Title: MTO2017 Radio Antenna Repositioning			
AG-SB-2020-07-B-EN		Compliance Category:	
Applicability		A - MANDATORY	
Aircraft type & model:	Affected Serial number(s):	B – RECOMMENDED	
AutoGyro MTO2017	All MTO2017 variants	C - OPTIONAL	
The maintenance manual to be referenced is this stated or subsequent issue.		As per AutoGyro website

AutoGyro has developed a potential means to improve the radio reception and transmission on the MTO2017.

(Pic. 1)

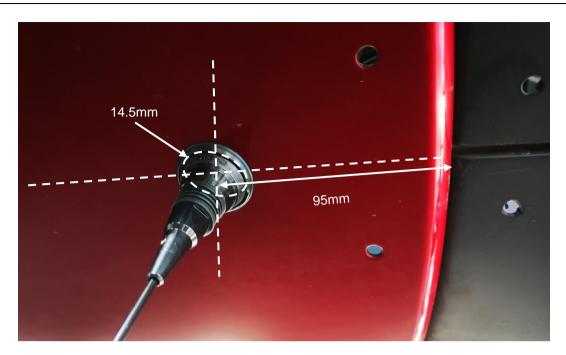
- 1. Ensure the wheel brakes are applied and the mag switches/ignition are switched in the "off" position.
- 2. Remove the 6 screws (3 left, 3 right) securing the oil cooler air scoop to the rear fairings and remove the scoop paying particular attention not to damage the antenna aerial (Pic. 1).

- 8. Re-secure the wiring behind the cockpit, and re-fit the left side rear cockpit cover removed in step 5.
- 9. Re-fit the oil cooler air scoop using Loctite 221 on all 6 screws (Pic 1).
